May 26, 2004

**MEMORANDUM TO TEAM LEADERS AND CONSULTANTS**

**SUBJECT:** Concrete Bridge Barrier Parapet Transitions and Approach Slabs

**APPROACH SLABS  
(34'-0" ROADWAY)**

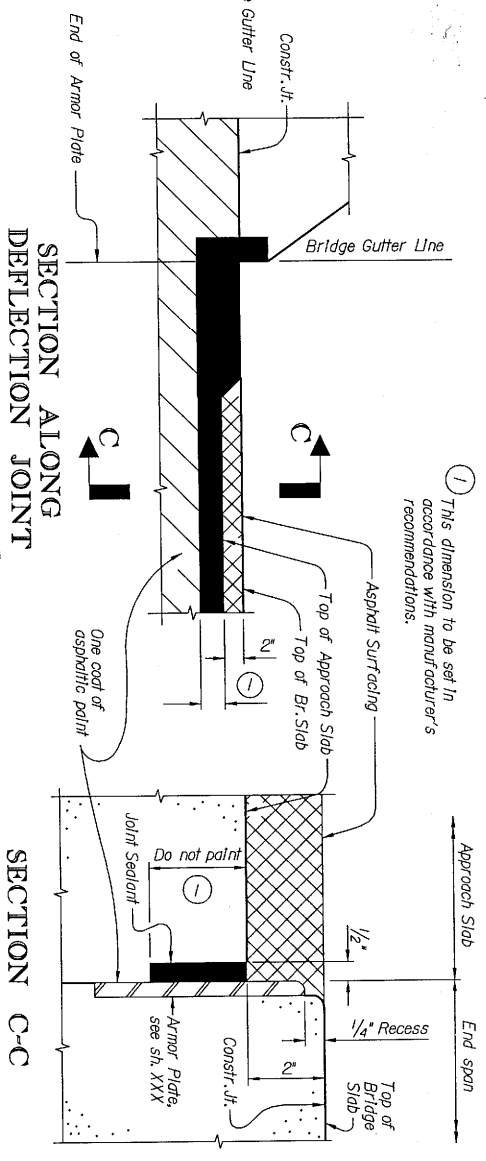
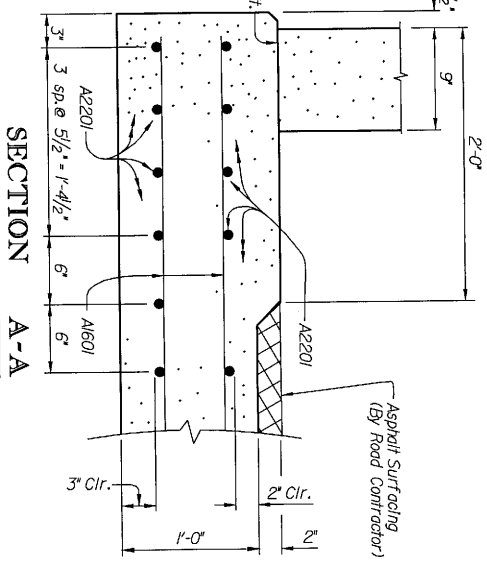
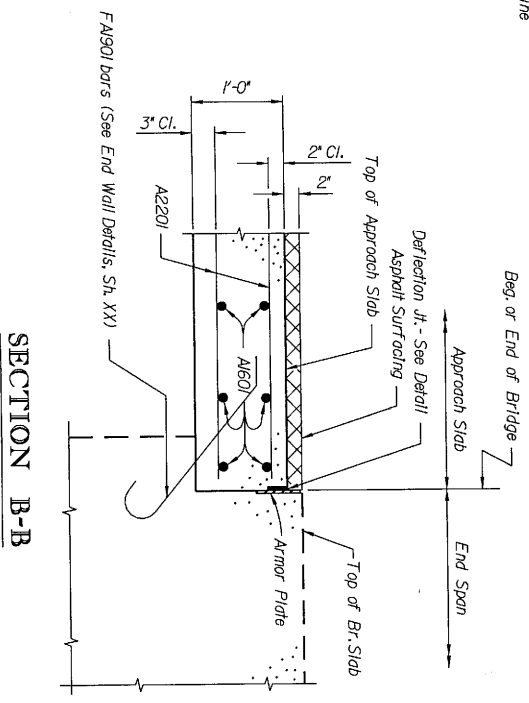
Effective with the November 2004 Letting, the Department will begin using a concrete bridge barrier parapet transition at all barrier ends where a three beam guardrail bridge connector is required. For bridges having parallel wing walls (wing walls that are parallel to the centerline of bridge), the transition shall be detailed as shown on the attached drawings. For bridges having straight wing walls (wing walls that are parallel to the centerline of bearing), the transition shall be placed on the end span, using details similar to the details shown on the attached drawing.

To accommodate the barrier parapet transition, approach slabs will be required for all bridges having parallel wing walls. For bridges with straight wing walls, approach slabs shall be detailed when any one of the following conditions exist:

1. The bridge is located on a primary route.
2. The bridge is located on a secondary or county road having a current ADT of 400 VPD or greater.
3. The bridge is located on a secondary or county road with a new approach fill height exceeding 10 feet.
